RC Transponder 2.4GHz

REVISION 1.20

Title	History					
Size A3	Document Number RC Transponder 2.4 GHz					Rev 12
Date:	Friday, January 07, 2022	Sheet	1	of	3

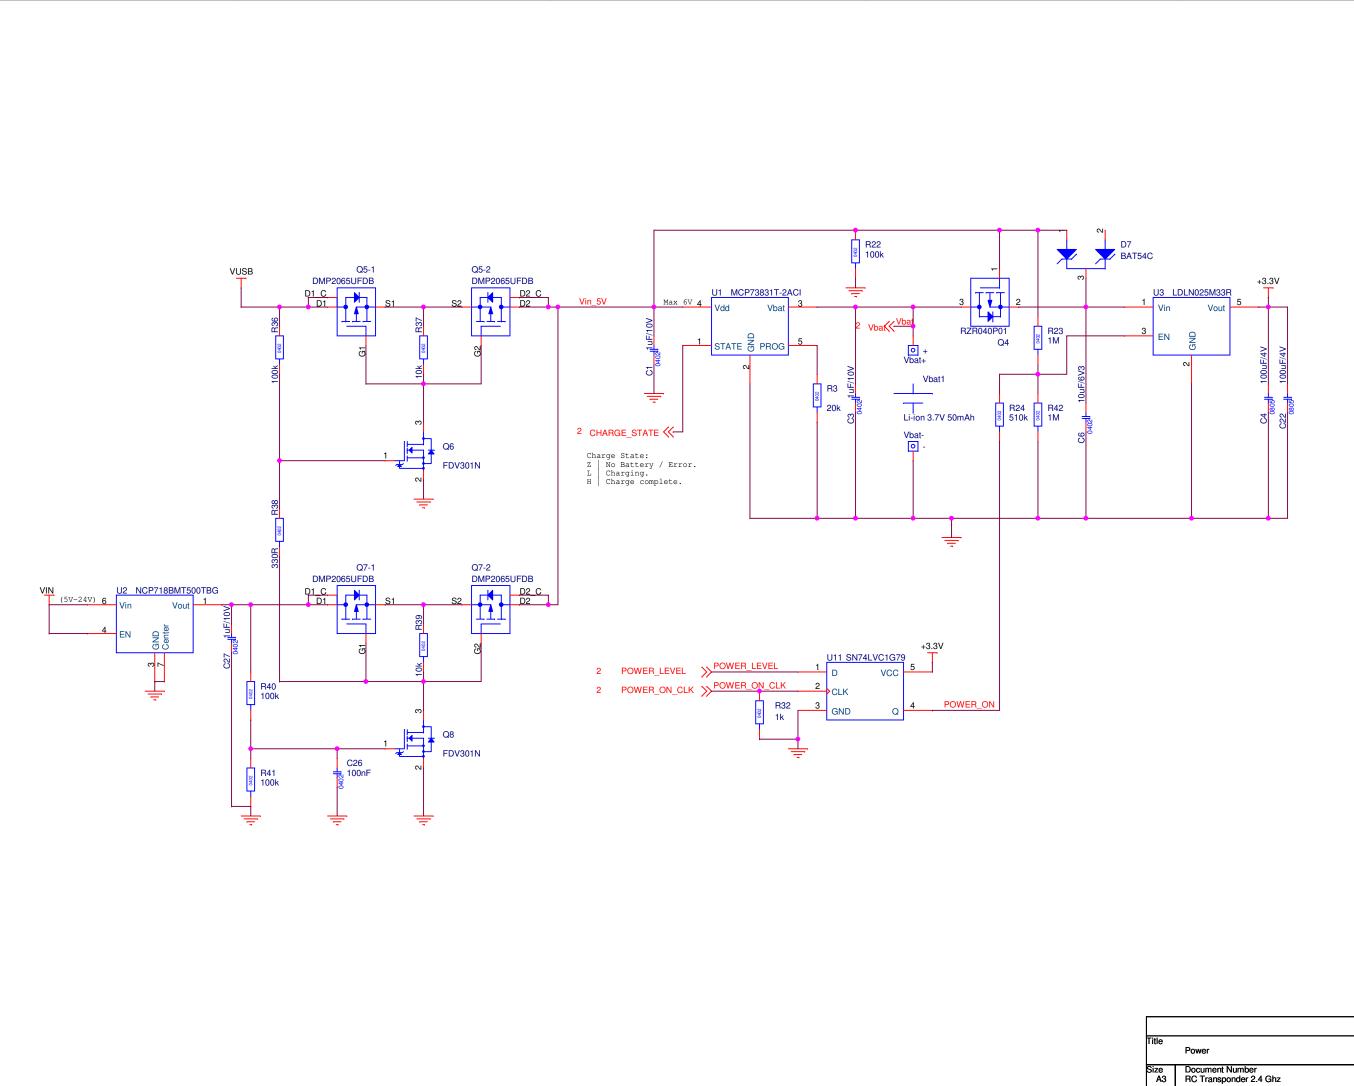
Revision	History	Responsible
1.00	1 st revision (Now obsolete)	Kenneth Lagoni Olsen
1.10	DIO1 connection added to CPU. R8 must be changed to ensure Vin-pin doesn't exceed 3.3V when input is 11V. Pull-down on serial input (to avoid junk trigger if floating).	Kenneth Lagoni Olsen

1.20	Updated: Input regulator U2 changed to be able to handle input voltage up to 24V (before 11V was max). Input power selectors changed from Diode to Fet type, to ensure minimal voltage drop when on. Regulator U3 changed to LDLN025M33R. Input connector changed from 1x10 DF13 to 2x3 DF13 and 1 SIL3 for more rubust connectors to RX. Vbat resistors R9 / R10 changed and upgraded to 0.1% for better accuracy. 5V measuring resistor R30 changed to 100K. And also changed to Vusb. GPS changed from PA6H to Quectel LR80. Also now with Reset option from MCU. Li-ion charger U1 changed to MCP73831T-2ACI for better Charge state output. Removed: Pressure sensor U9 removed. RC / SBUS input removed. Added: Power On from MCU is now via flip-flop U11 in order to allow software to reboot without losing power.	Kenneth Lagoni Olsen
	Charge state input to MCU for better battery monitoring. J6 connector for easy bootloader programming.
